UPGRADING BRUSHED TWIN TO BRUSHLESS TWIN COMPRESSOR

07/11/2024

BRUSHLESS MOUNT HOLE PATTERN OVERLAID WITH BRUSHED TWIN MOUNT

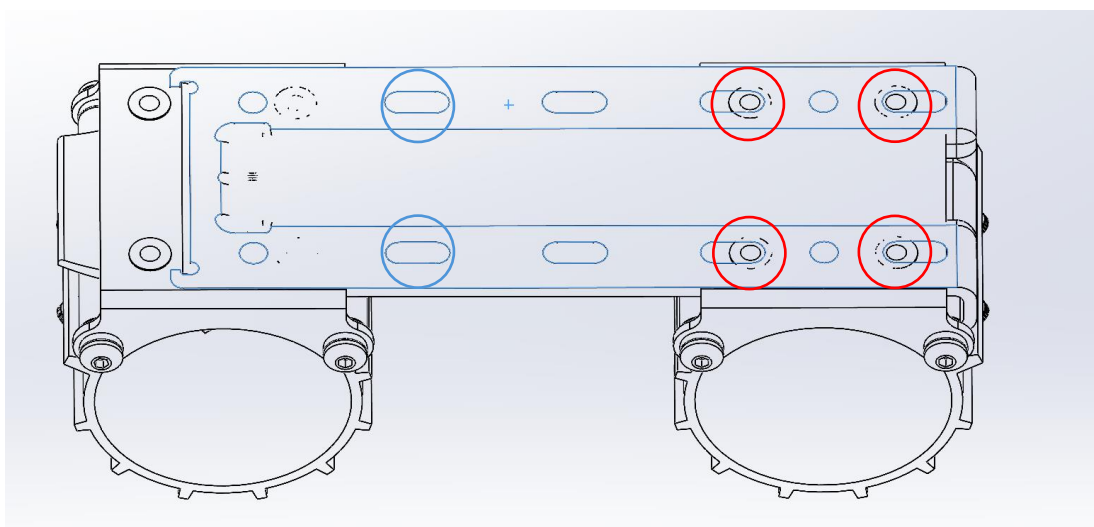
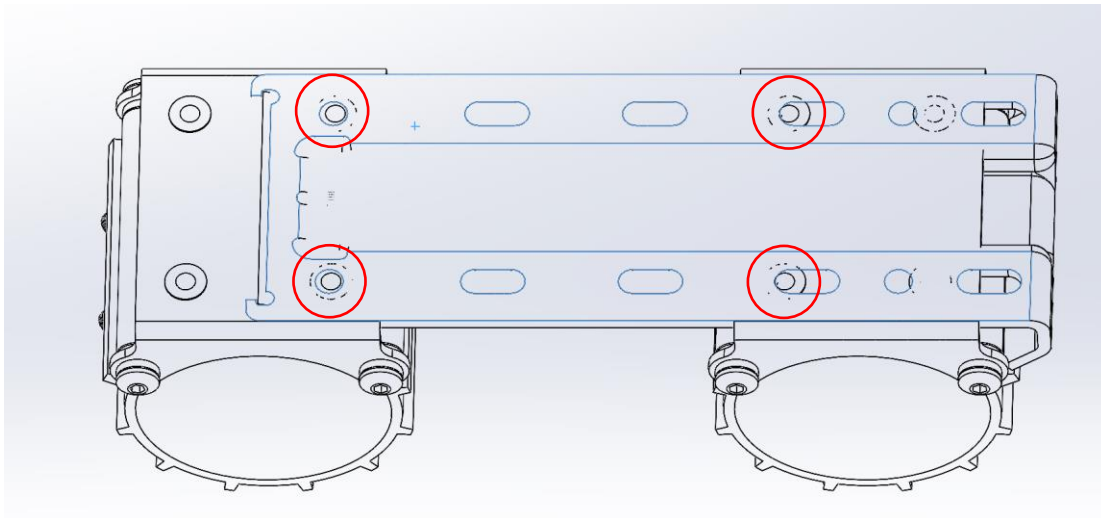
If upgrading a pre-installed brushed twin compressor to a brushless twin it should be noted that due to the new brushless compressor being physically smaller there was no way to fully re-use the mounting hole pattern. However, no more than 2 new holes should be required to be drilled to complete the upgrade.
